UNITED STATES PATENT AND TRADEMARK OFFICE

APPLICATION NO.	FILING DATE	FIRST NAMED INVENTOR	ATTORNEY DOCKET NO.	CONFIRMATION NO.
10/812,360	03/30/2004	Katsunari Morishima	001309.00058	4113
22907	7590	08/01/2006	EXAMINER	
BANNER & WITCOFF 1001 G STREET N W SUITE 1100 WASHINGTON, DC 20001			MITCHELL, KATHERINE W	
			ART UNIT	PAPER NUMBER
			3677

Office Action Summary	Application No. 10/812,360	Applicant(s) MORISHIMA ET AL.	
	Examiner Katherine W. Mitchell	Art Unit 3677

DETAILED ACTION

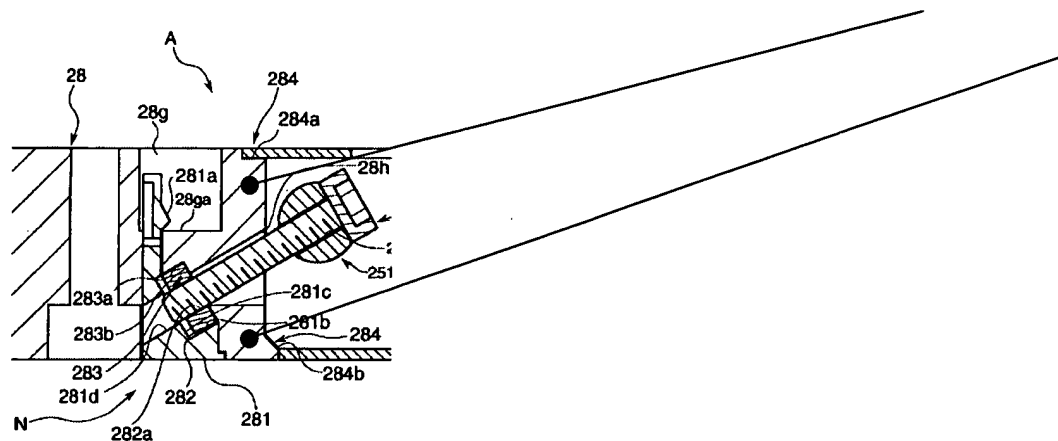
17. Applicant argues that the drawings are clear due to the nature of the lead

lines and lead lines with arrows. Examiner disagrees - see drawing objection above.

More importantly, examiner noted in both the drawings and the specifications that it was not clear exactly what was the nut retainer 283 and the nut retaining apparatus N. The only body disclosed is connecting body 28, so that is the body, but examiner believes there is much room for argument about what is the nut retainer, what exactly is the nut retaining apparatus, and now what exactly is the end surface of the body. Examiner believes 28 is clearly shown as the body, which comprises the nut retaining apparatus,

and the nut retaining apparatus comprises the nut retainer and nut holder 281, but it is not at all clear to examiner what structurally comprises the nut retaining apparatus, and since the nut retaining apparatus comprises the nut retainer, what structurally comprises the nut retainer. Is the nut retainer the enlarged recess at the end of the bolt hole that holds the nut, (examiner believes this is 28c) or is it the/a structure pointed out below:
